**MODIFICATION REQUEST TO CONCEPT APPROVAL
AND PROJECT APPROVAL:**

**Former Rachel Forster Hospital (134-144 Pitt Street,
Redfern)**

MP 07_0029 MOD 1 and MP 09_0068 MOD 1

Secretary's Environmental Assessment Report
Section 75W of the *Environmental Planning and
Assessment Act 1979*

Figure 8: Proposed Site Plan (Base Source: Proponent's RtS)

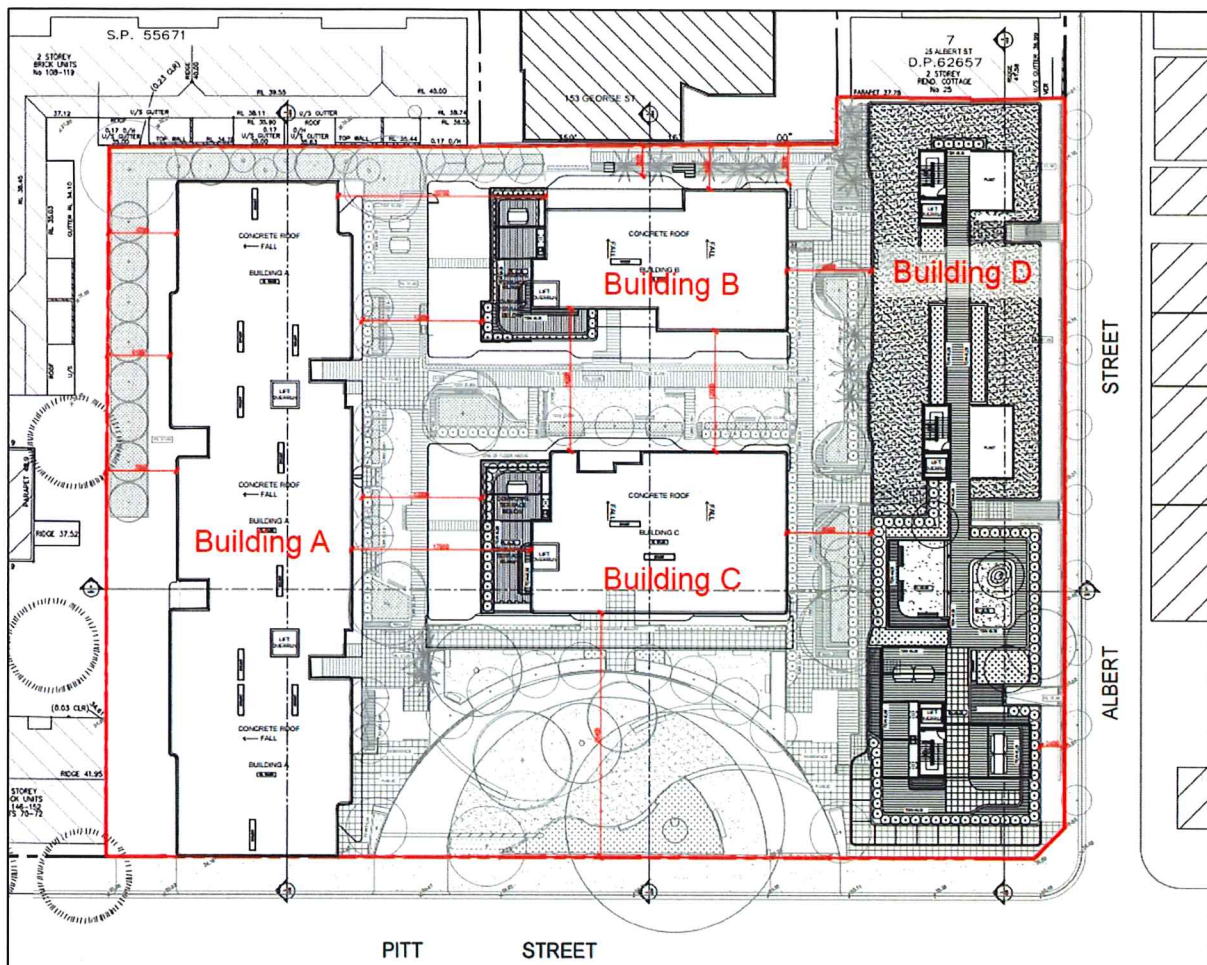
- is setback approximately 24 m from the Pitt Street frontage behind the landscaped forecourt, which maintains the prominence of Building A (which has a zero setback to the Pitt Street frontage) in its current setting (**Figure 8**). This generous setback, along with retained trees and new landscaping toward the Pitt Street frontage, will reduce any potential visual prominence of the additional two storeys on the streetscape

Figure 10: North/South cross section showing Buildings B C and the neighbouring property 153 George Street to the right (Base Source: Proponent's RtS)

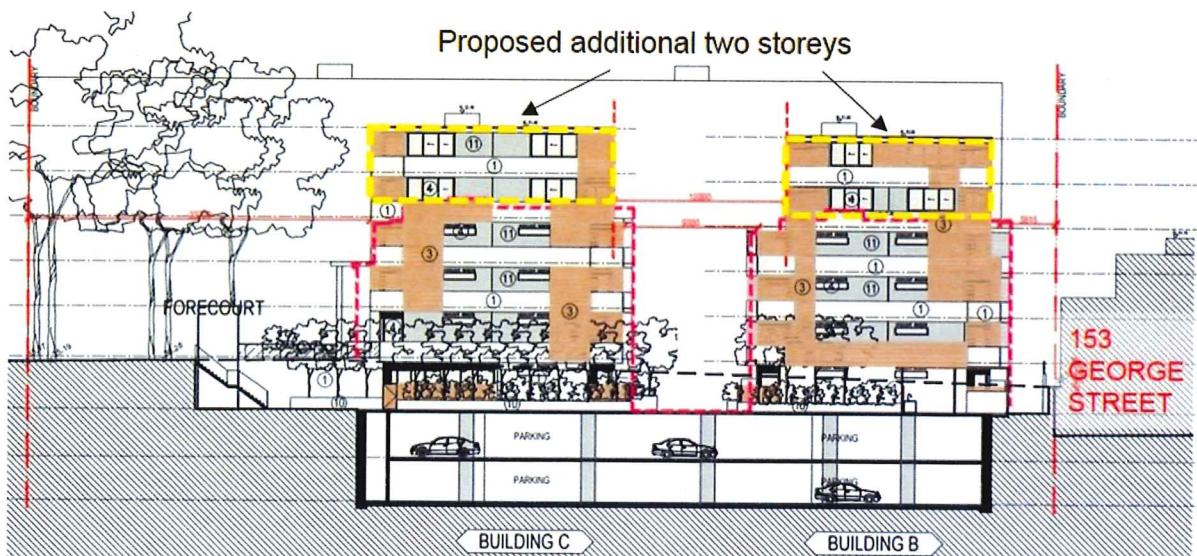
- the two additional storeys sit above the four storey height of 153 George Street (**Figure 10**) and predominately overlook the roof of the building
- the Proponent's overshadowing analysis demonstrates only minor additional impacts to upper level bedrooms of neighbouring properties to the east between 9 am and 10 am in mid winter, from the two additional storeys, which does not cause adverse overshadowing impacts.

Figure 11: Western elevation of Building B, with Building D to the left and Building A to the right (Source: Proponent's RtS)

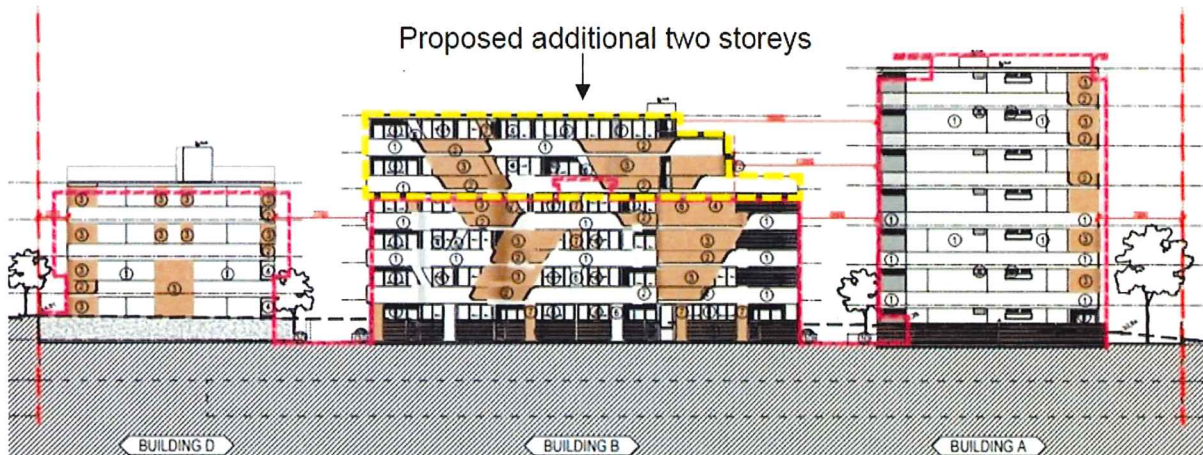
Building B is located at the rear of the site, and is screened from view from Pitt and Albert Streets by Buildings C and D located along these frontages. The Department is also satisfied that Building B responds in a positive manner to Building A, being approximately 4 m lower in height and providing a setback of 12 to 20.7 m to the upper two levels (Figure 11).

Figure 12: Northern and eastern elevation of the former surgery building (Building A) and eastern elevation of the former Administration Block (Building C) and the forecourt as viewed from Pitt Street (Source: Rachel Forster Hospital CMP)

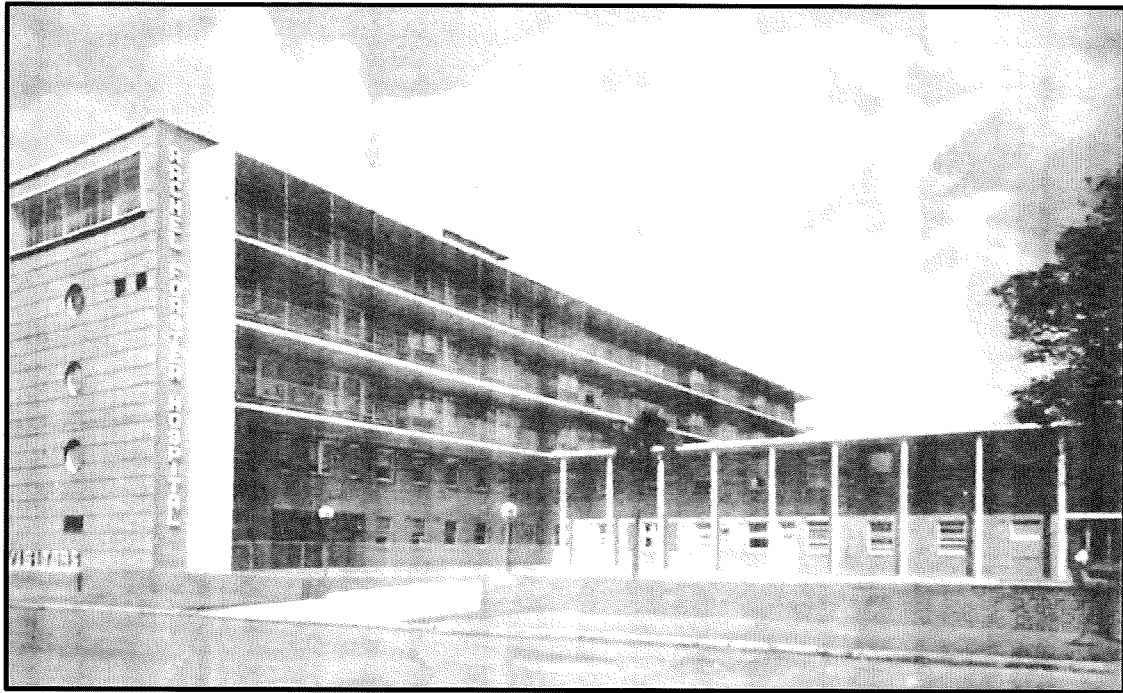
The CMP identifies the northern and eastern elevations of Building A have exceptional significance (Category A) and form part of the iconic views to the site from the Pitt Street view corridor (**Figure 16**). The CMP also notes the remaining elevations of Building A are of moderate significance (Category C).

The Department notes the eastern elevation of Building A has been retained in generally good repair but the northern elevation in particular is largely dilapidated. In addition, the Project Approval permits the full reconstruction of the northern elevation of Building A, as well as minor demolition and re-construction works on the eastern elevation.

Figure 17: Comparison of the approved (orange) and proposed (yellow) building separation (Base source: Proponent's RtS)

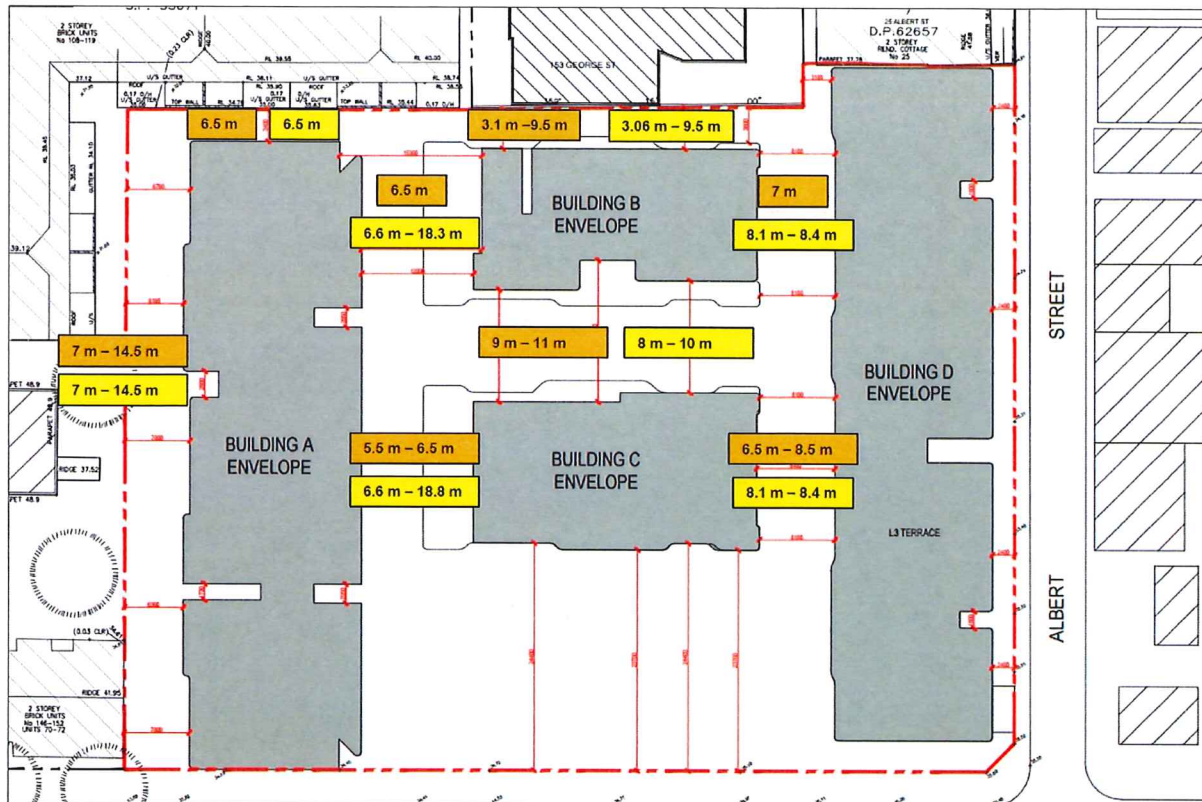
- increases between Building A and Buildings B/C (5.5 - 6.6 m to 6.6 - 9 m)
- increases between Building D and Buildings B/C (6.5 7m to 8.4 m)
- reduction between Buildings B and C (9 - 11 m to 8 - 10 m) (**Figure 17**).

The Department notes the proposed separation between Buildings A, B, C and D is largely consistent with the Project Approval (**Figure 17**) and on balance the proposal achieves an equivalent level of separation.

In relation to the further reductions, the Department notes that while separation at its narrowest is 8 m, the curved facades provide undulating separation which on balance is considered to achieve equivalent levels of visual and acoustic privacy to the approved development. In addition, the 1 m reduction in separation between Buildings B and C, is offset by equivalent increases in separation between Buildings A and D and B/C.
